6611C-07A

S E R V I C E N O T E

Agilent 6611C DC Power Supply

On faster computers, when programming over GPIB, a random error will occur.

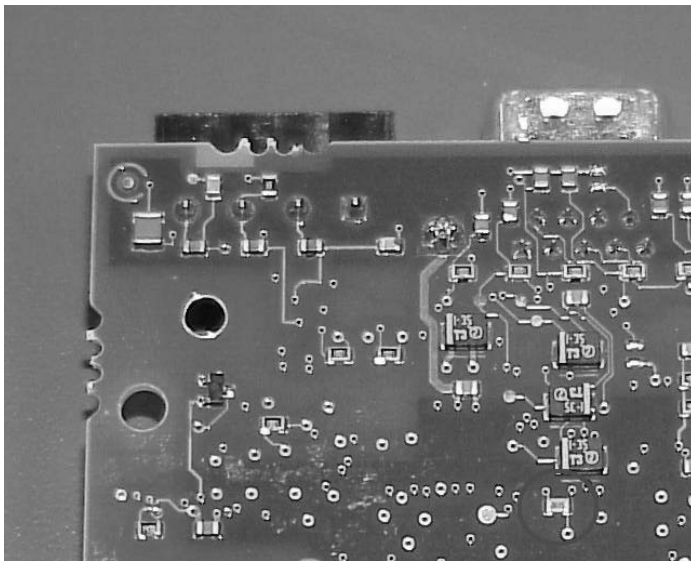
When programming a unit over GPIB, a random error -113 (“Undefined header”) will appear on the unit. This error can be read back via the front panel or over the GPIB bus.

Change resistor R1246 (see picture for location) from 511 Ohms to 100 Ohms (part number 0699-3058). This requires un-soldering and soldering a surface mount component and can be very difficult. This does not require re-calibration.

Replace the entire GPIB assembly (part number 5063-4841) with a newer one that has the 100 Ohm resistor. This will require the unit to be re-calibrated.
